FRANKFURT SHORT & COMPANY, P.C.  
By: *[Signature]*  
SUBMITTAL NO. 9126-1320A-02-02

STRAND HUNT CONSTRUCTION SUBMITTAL/SHOP DRAWING REVIEW	
Project No.	92-281
Submittal No.	13.120A-02-02, Item #4
Spec. Section	13.120
<input checked="" type="checkbox"/> These documents have been reviewed and are in general conformance with the plans and specifications.	
<input type="checkbox"/> These documents have been reviewed and are not in general conformance with the plans and specifications.	
Revised and resubmit by	
Reviewed by	Date

Builder:	Seattle Construction Services, Inc.		
Owner:	Alaska Industrial Development and Export Authority		
Building:	Line Maintenance Hangar		
Location:	Anchorage, Alaska		
DRAWN BY	LMC	JOB NO.	51-9290
CHECKED BY	RAY	DATE	2/94
		DWG.	AB-01

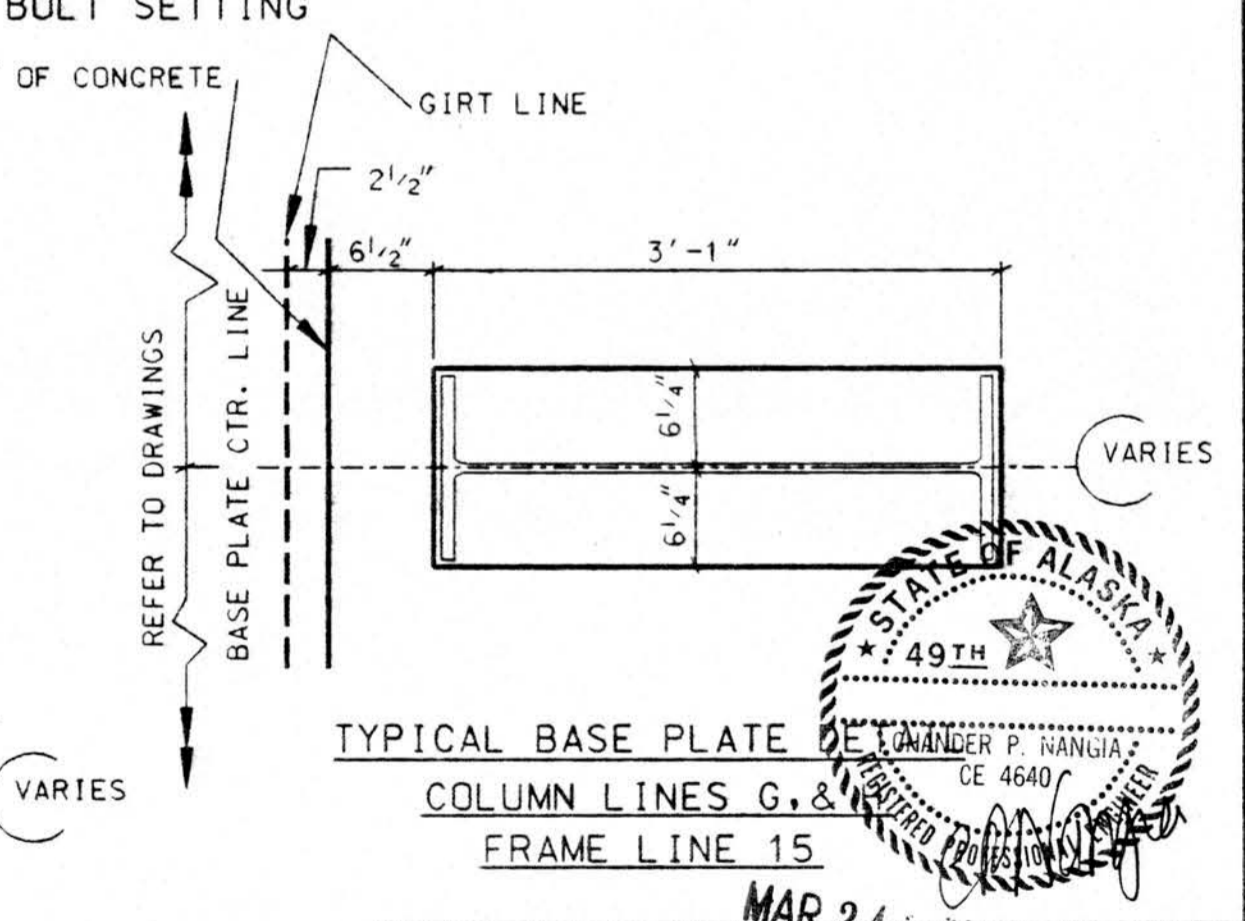
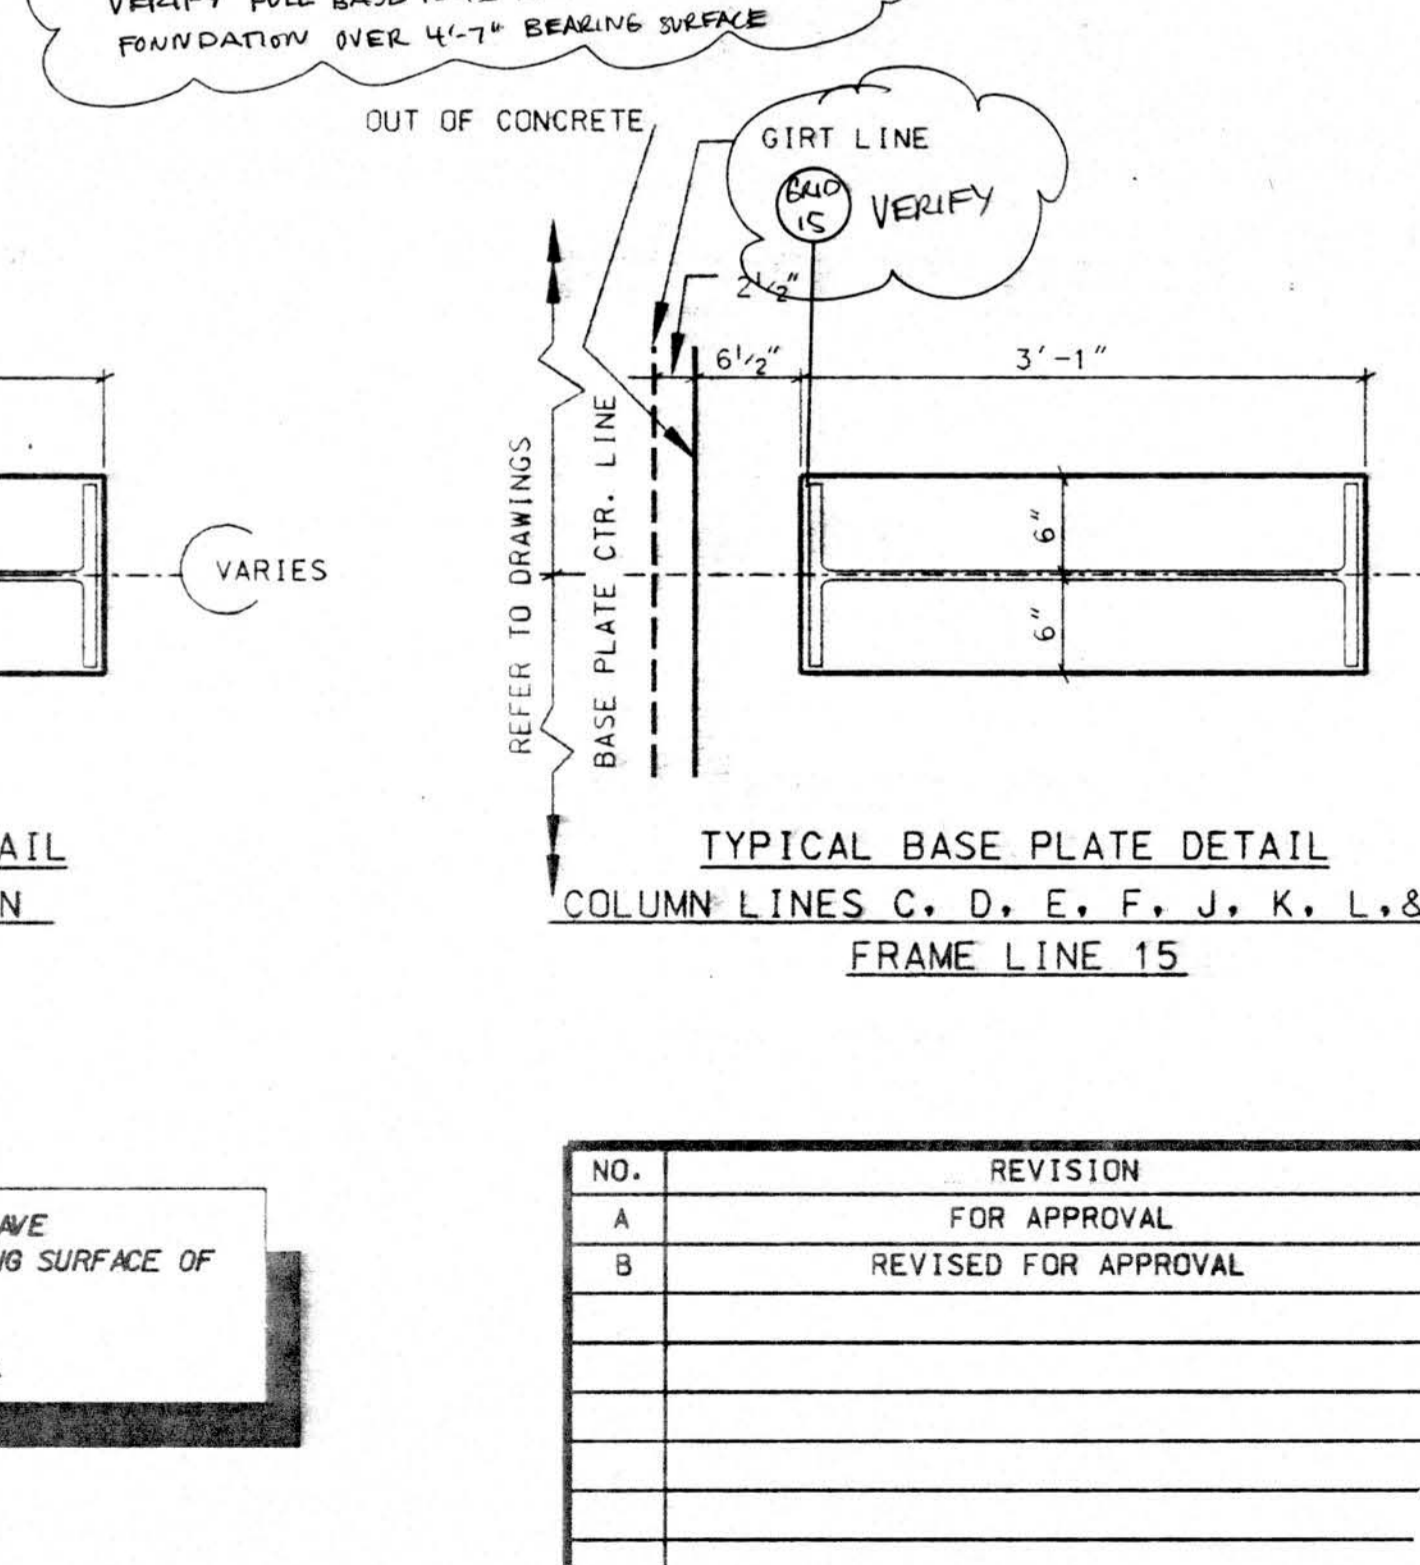
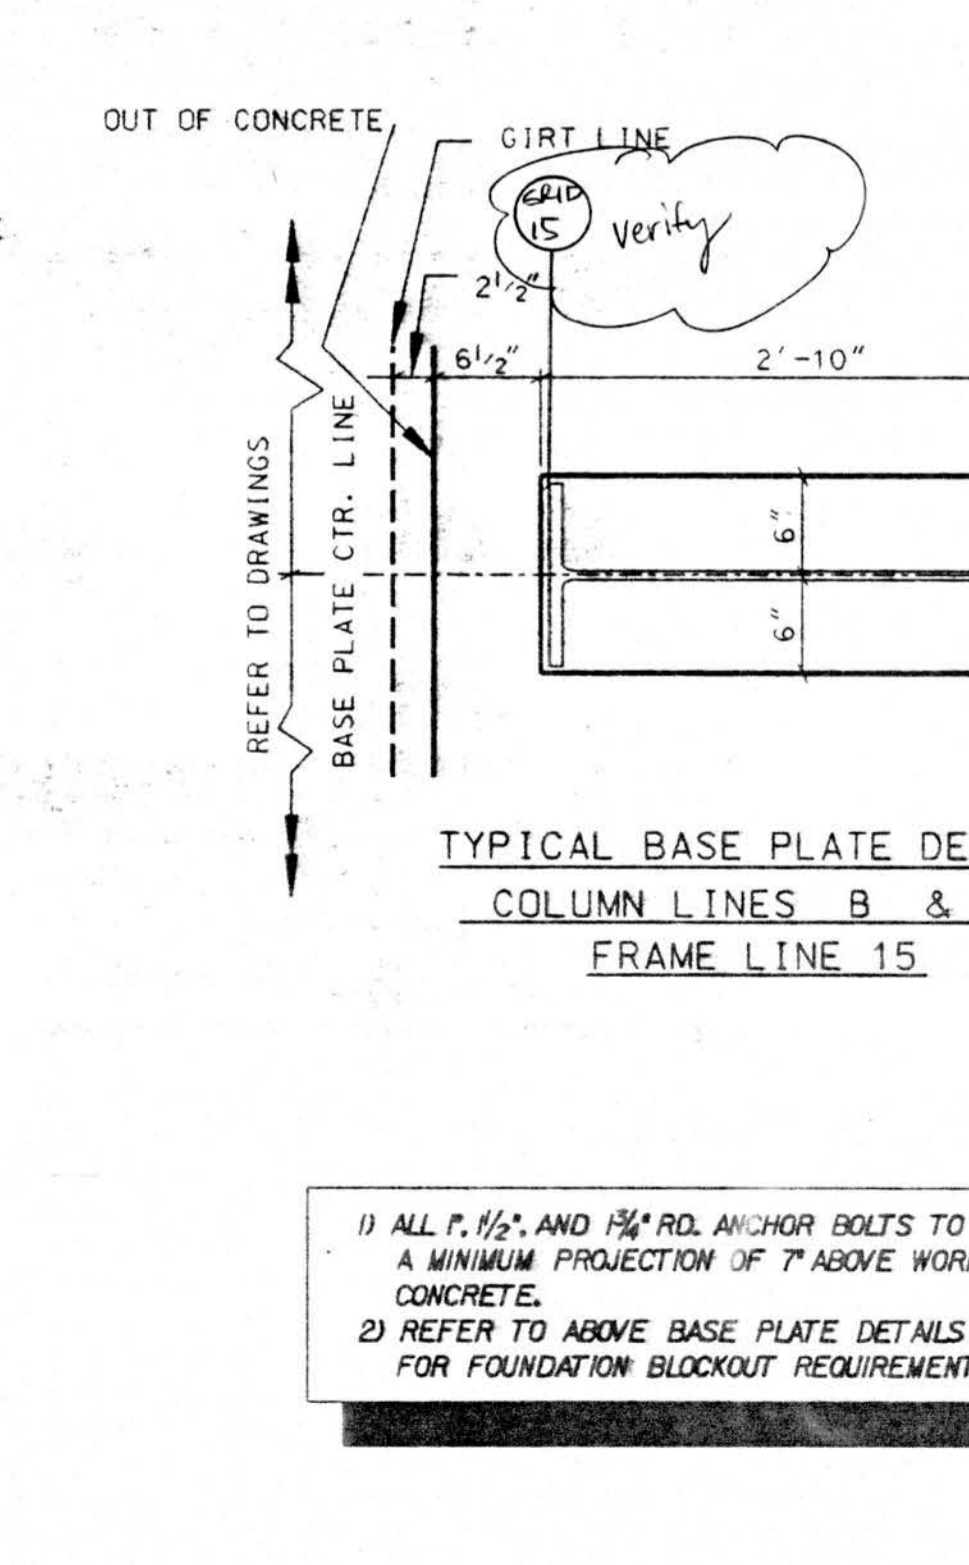
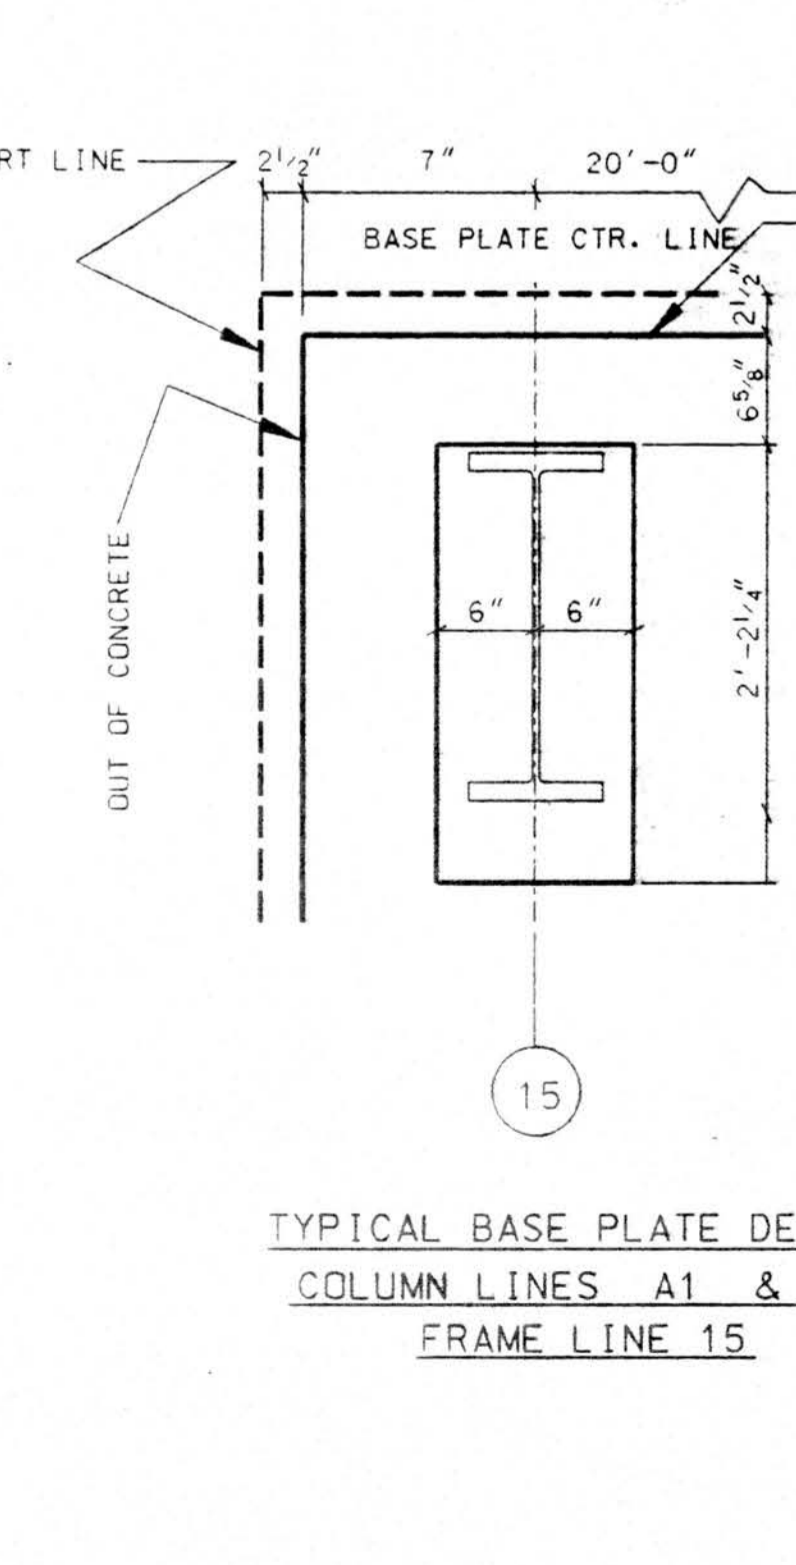
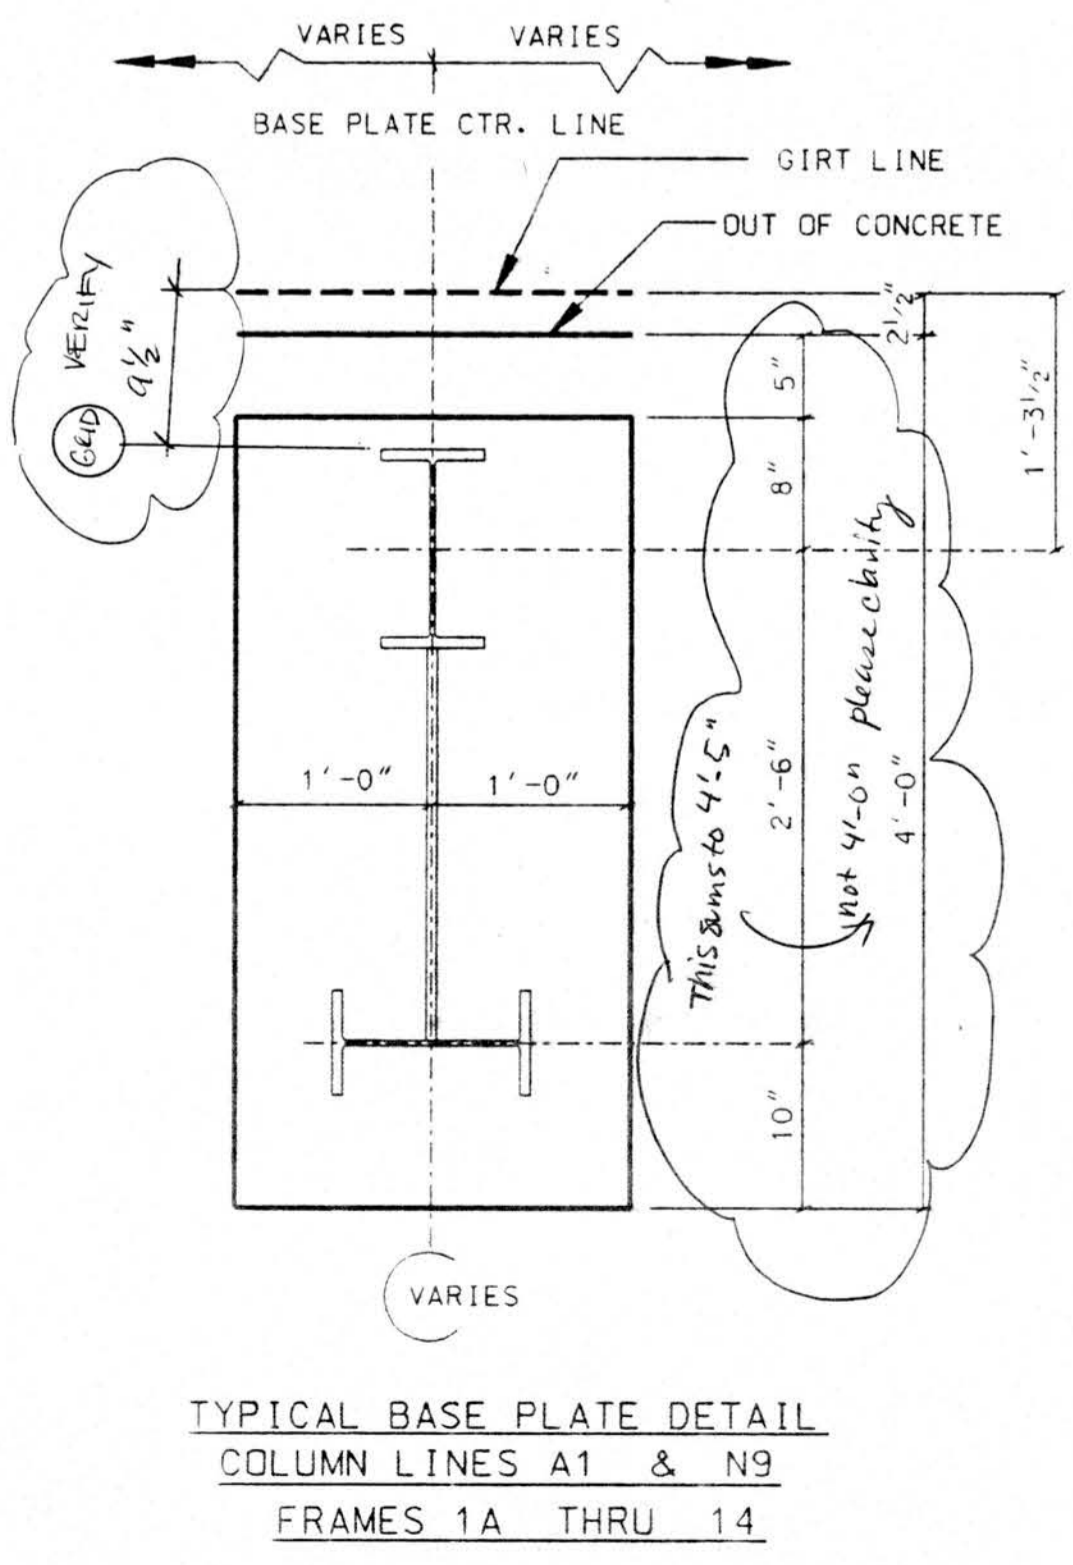
CLIENT PLEASE NOTE MINIMUM COLUMN BLOCK-OUT REQUIREMENTS FOR FOUNDATION.  
 SAME COMMENT APPLIES: BLOCKOUT IS 4'-7"  
 VERIFY FULL BASE PLATE BEARING ON CONCRETE FOUNDATION OVER 4'-7" BEARING SURFACE
